PLANNING COMMISSION PUBLIC HEARING

FILE NO.: DR-09-11/VAR-10-01

**REQUEST: CLASS II DESIGN REVIEW FOR NEW CITY
PARK WITH CLASS II VARIANCE REQUESTED
FOR DRIVEWAY WIDTH**

**CITY OF WEST LINN
PLANNING & DEVELOPMENT
STAFF REPORT**

DRAWING NO.
WL-504A

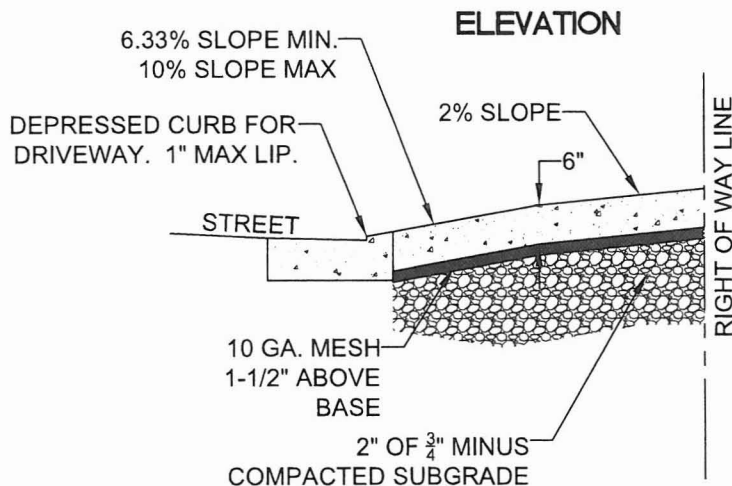
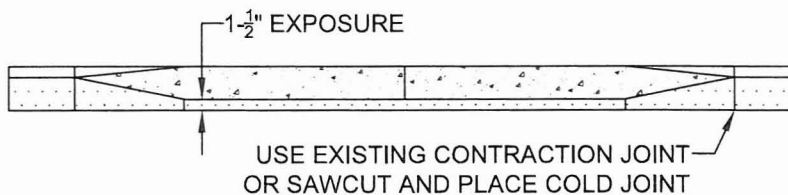
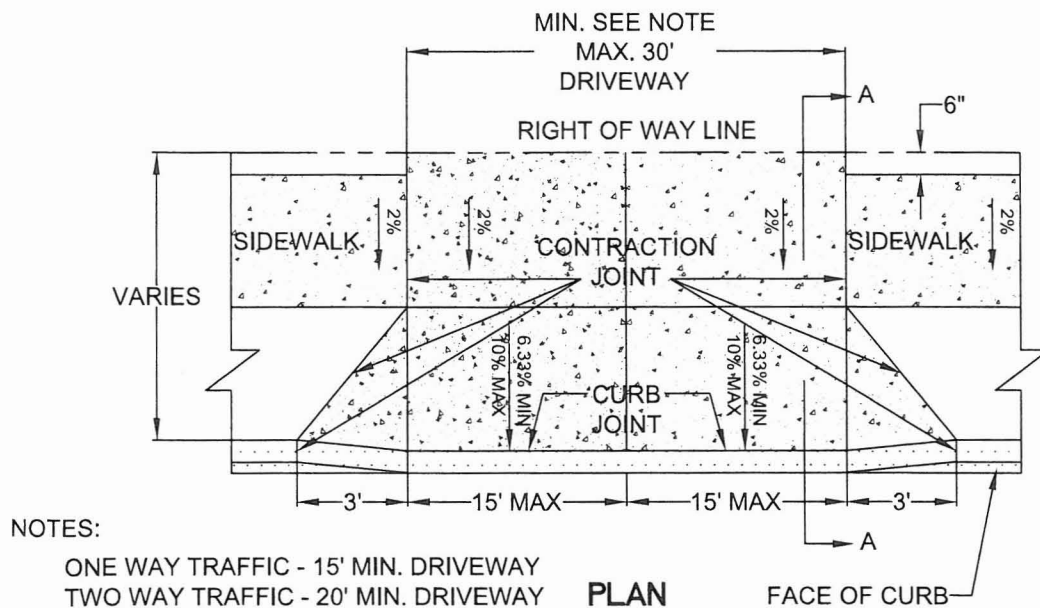
In accordance with the City of West Linn Construction Standard Detail Drawing WL-504A, a commercial driveway shall require a minimum width of 20' for two way traffic. No curb shall be required along the edge of the driveway pavement for the length of the driveway located inside the public right of way. Please see attached detail.
